ADDENDUM # 2 - PAGE 1 of 11

RFP TITLE: CAMERON COUNTY BEACH ACCESS No.3 IMPROVEMENTS PHASE II

RFP NUMBER # 250501

CONSTRUCTION PLANS
FOR
CAMERON COUNTY
ISLA BLANCA
BEACH ACCESS #3
SOUTH PADRE ISLAND, TEXAS

GRADING PLAN

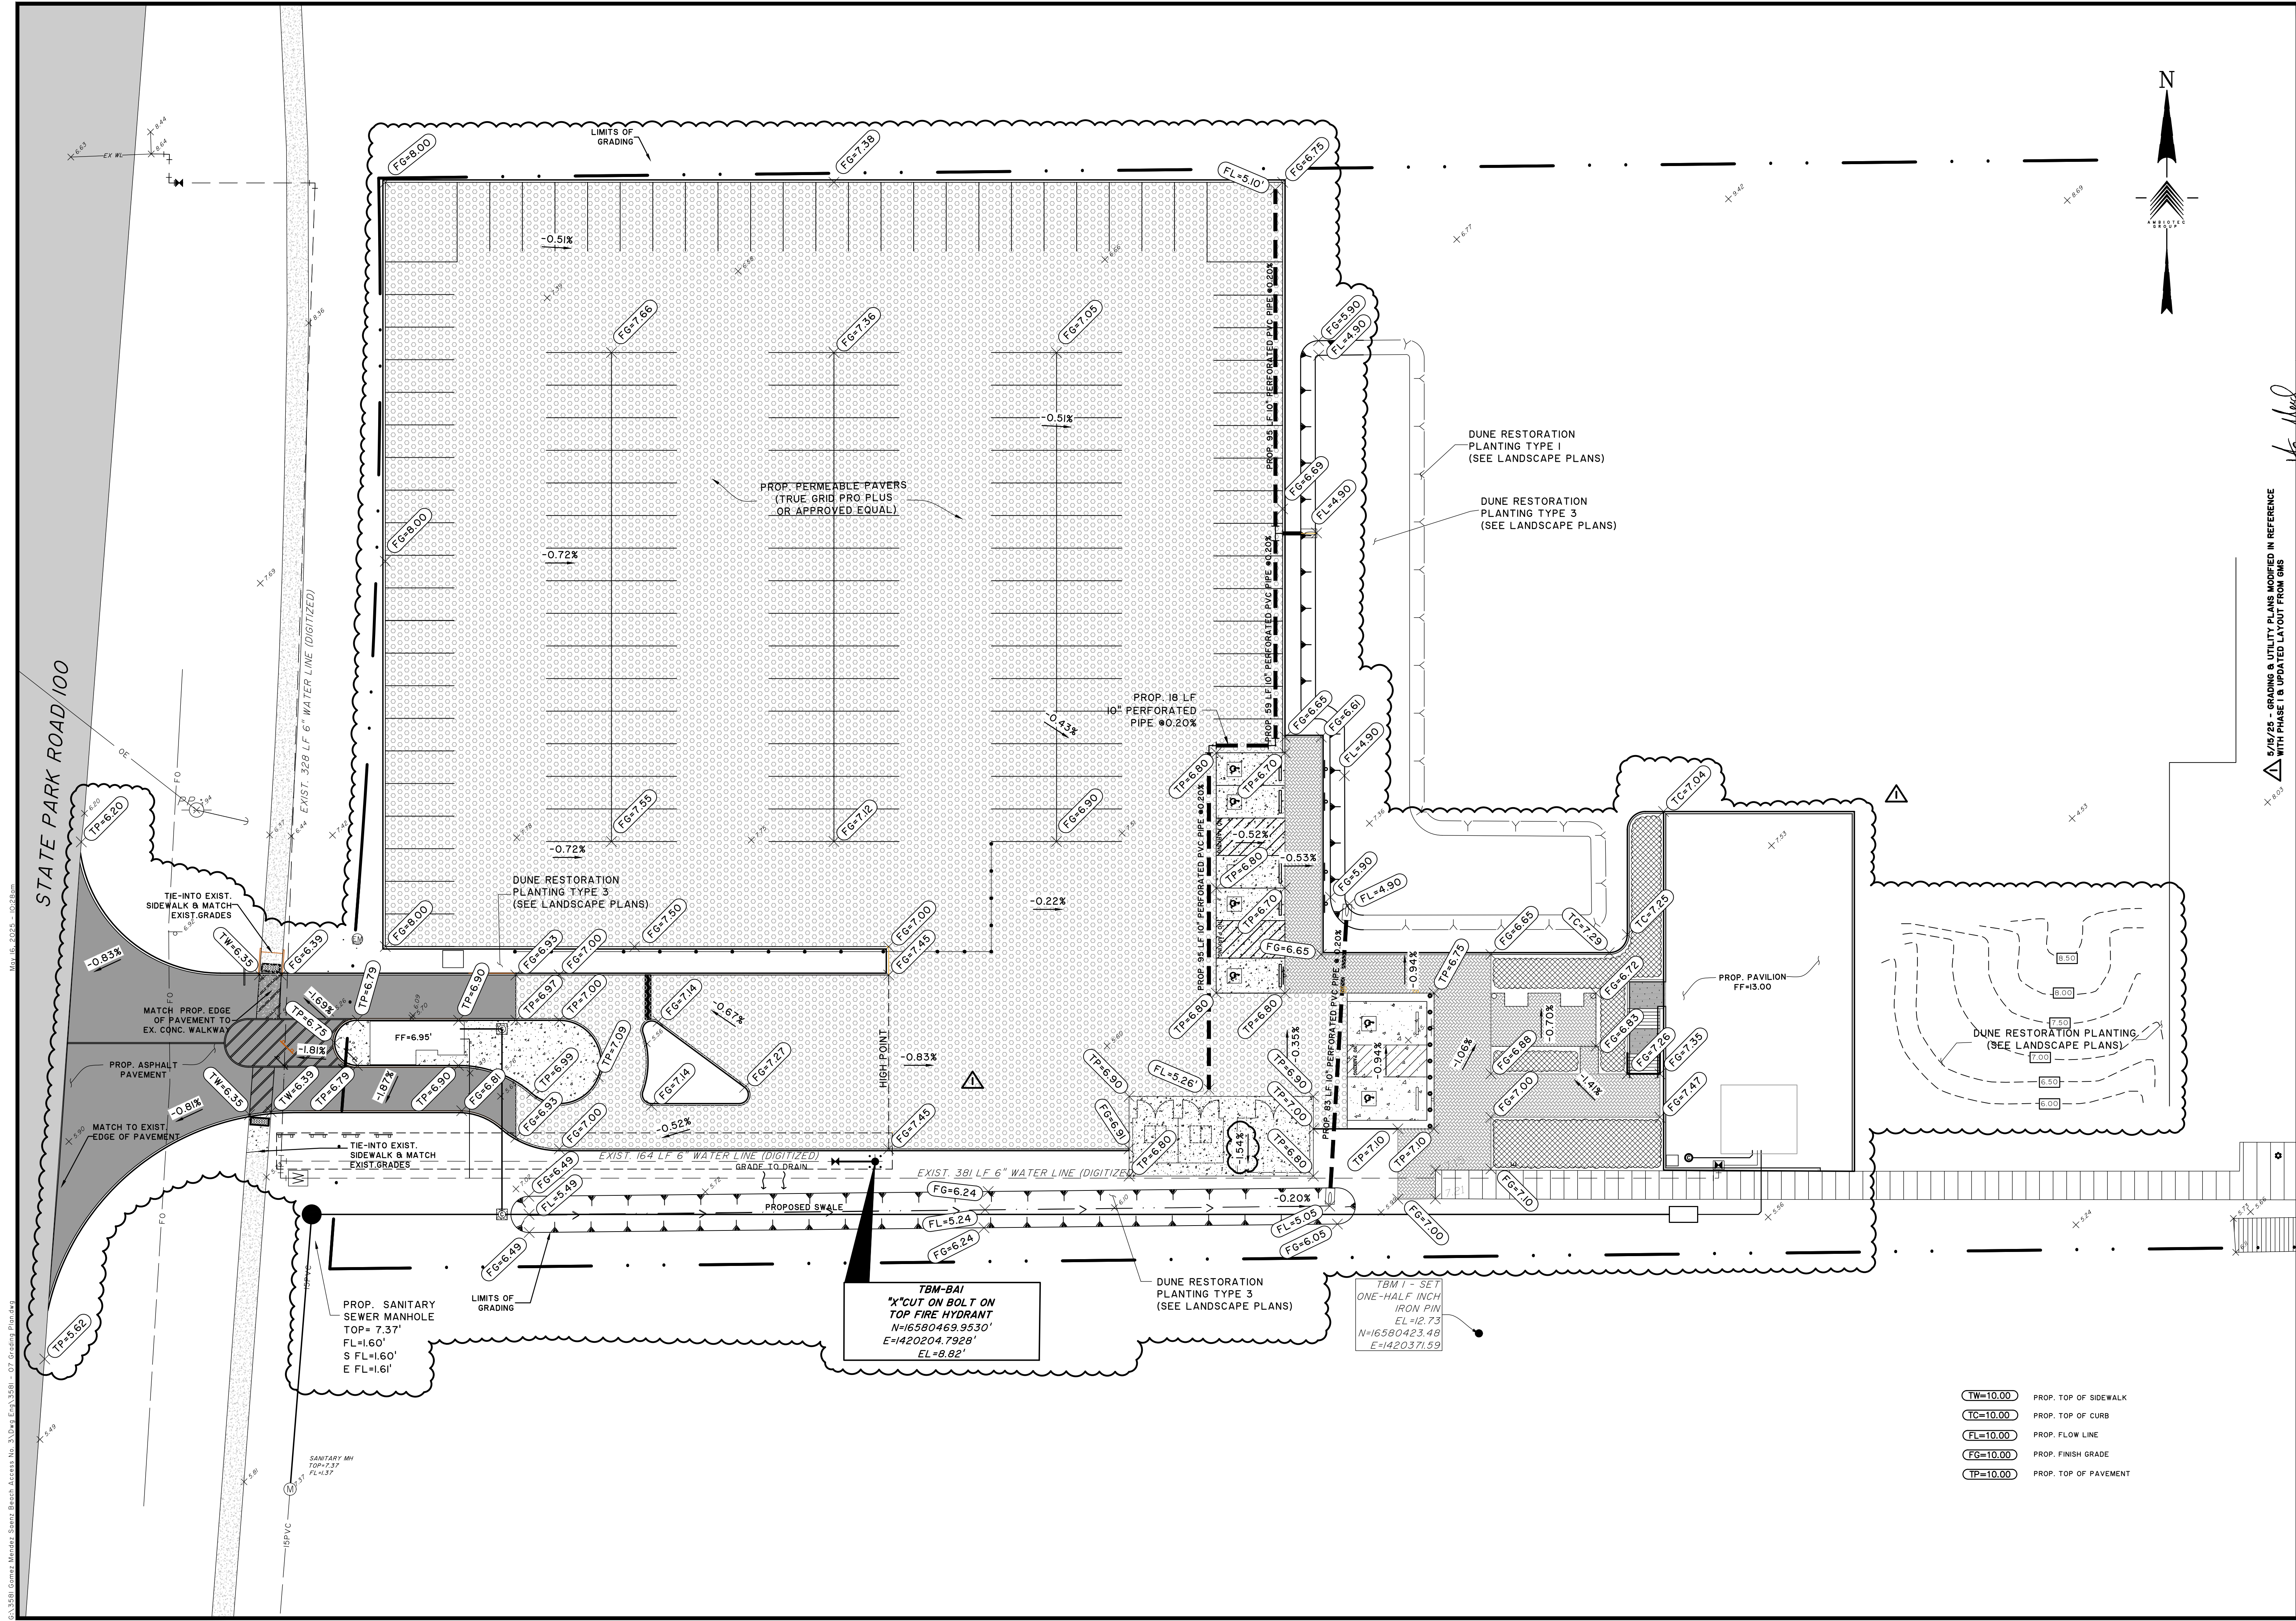
5/15/25 - GRADING & UTILITY PLANS MODIFIED IN REFERENCE WITH PHASE I & UPDATED LAYOUT FROM GIS
